EVALUATION  
OF  
FIRE DOORS 3-20 AND 3-13  
AT  
FERMI 2  
DETROIT EDISON CO.

Date Submitted: January 31, 1985

Prepared by: Robert J. O'Laughlin, P.E., CSP  
Senior Fire Protection Engineer  
Professional Loss Control, Inc.

FIGURE 1

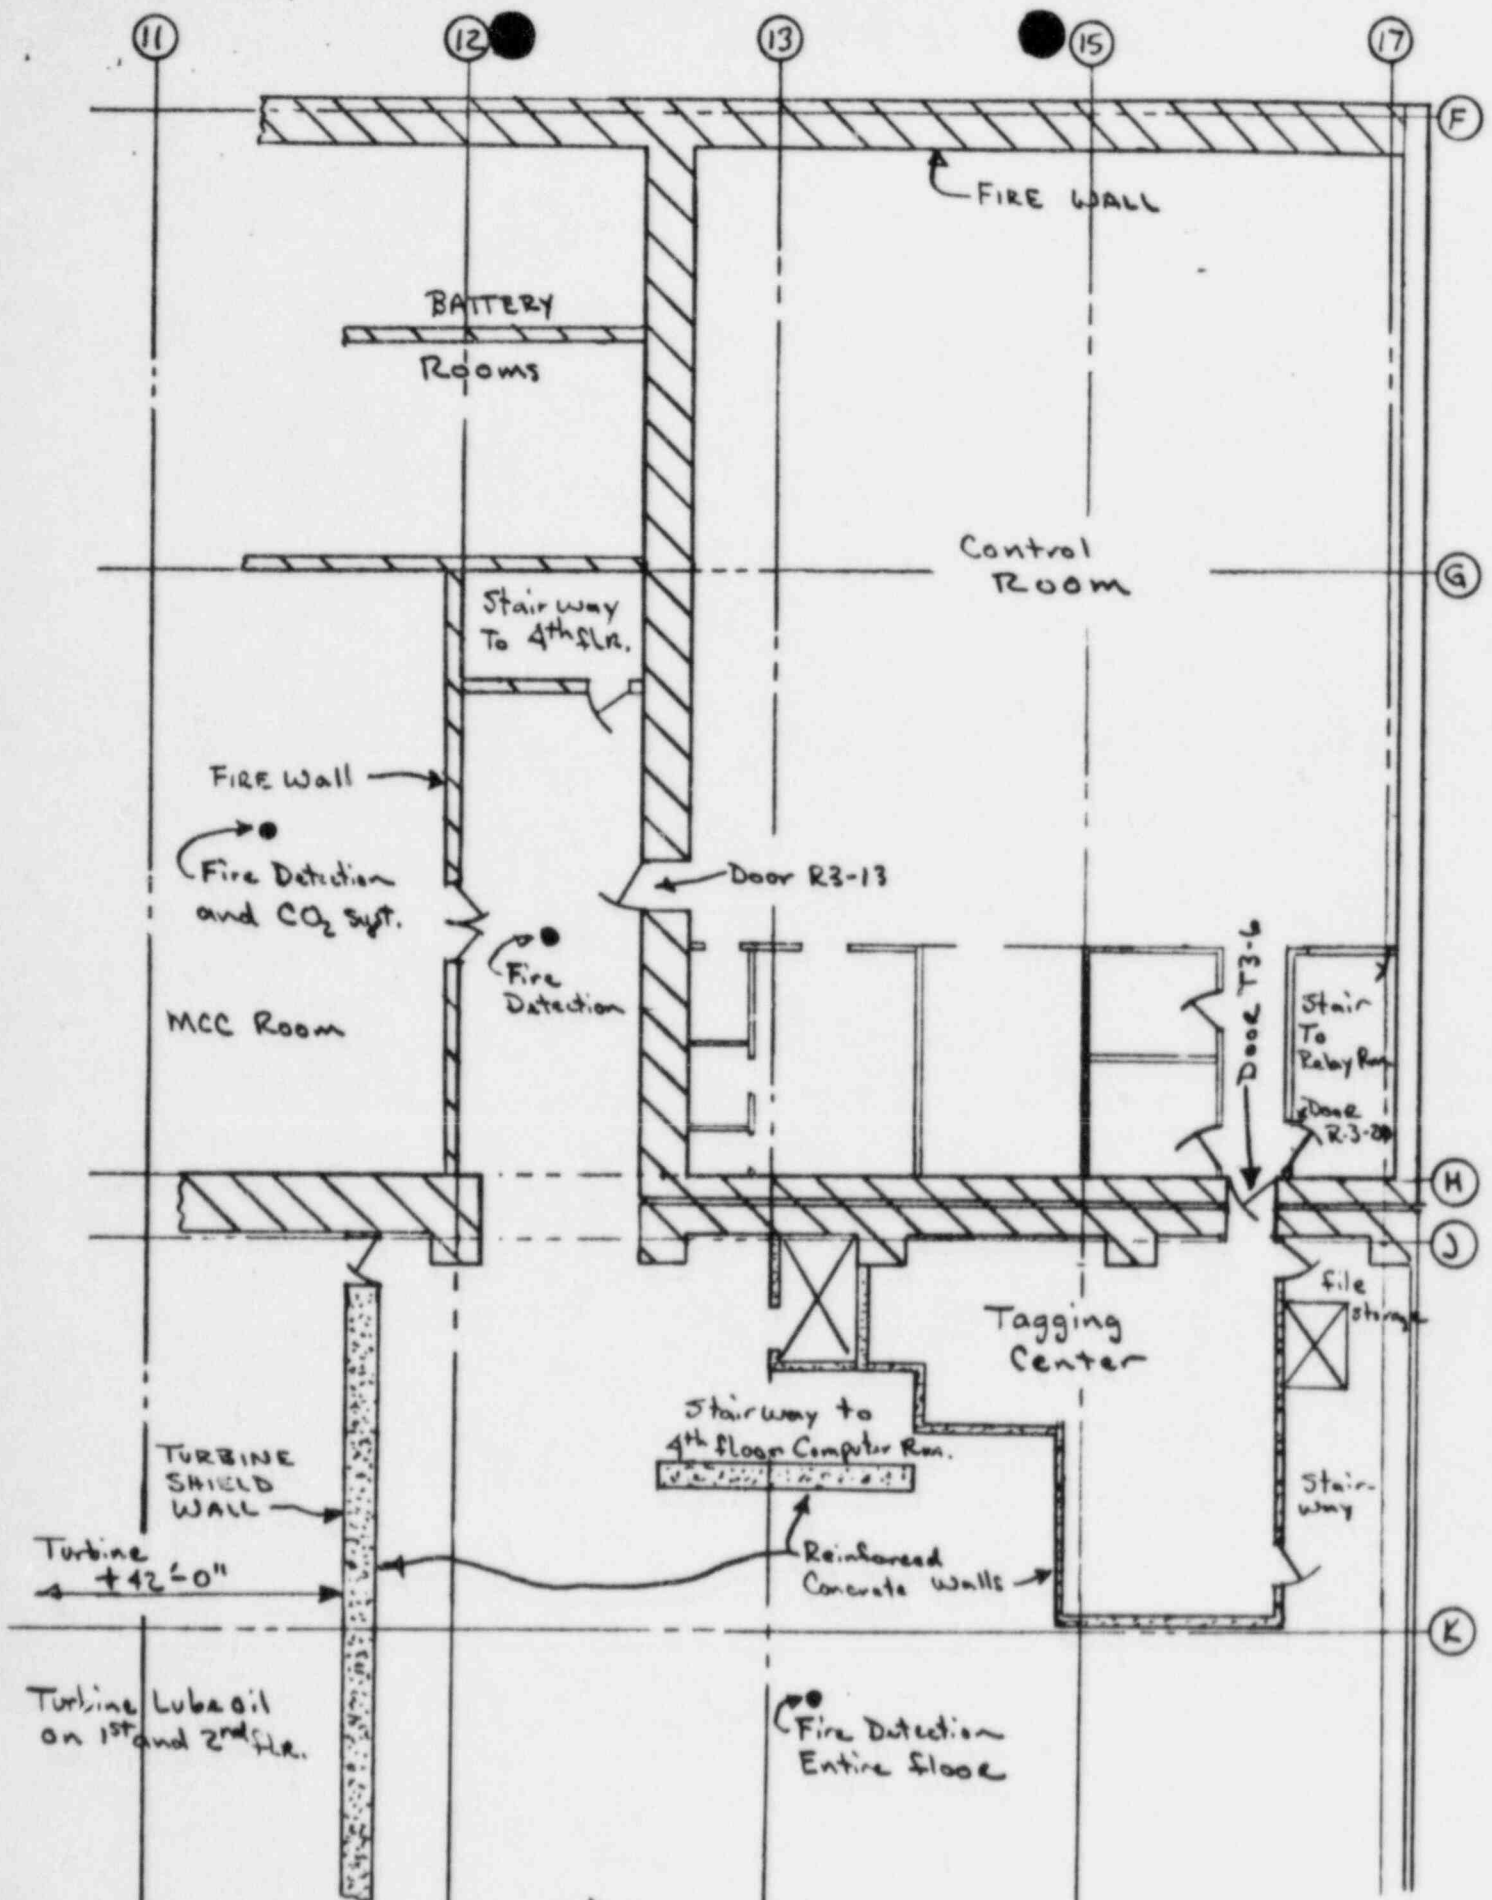
Door R3-20 separates the control room from the stairwell in the northeast corner of the control room. The stairwell construction has a two hour fire resistance. The control room is enclosed in a three hour fire resistive envelope except the north exterior wall. (Refer to Sketch No. 1).

Door R3-13 separates the control room from the Turbine Bldg. extension, floor elevation 643'-6". This security door is installed in a 3 hour fire resistance wall on the south side of the control room. This door is located approximately 25 ft from the main Turbine Building floor. (Refer to sketch No. 1).

Door 3-13 is considered adequate for its installation in the 3 hour rated fire wall even though an additional 5/16 inch gap occurred at the transom panel. This is considered a minor deviation from the acceptance criteria. In addition, the Turbine Building extension contains no fixed combustible material and therefore, does not present an exposure hazard to the door assembly. Transient combustibles are controlled procedurally.
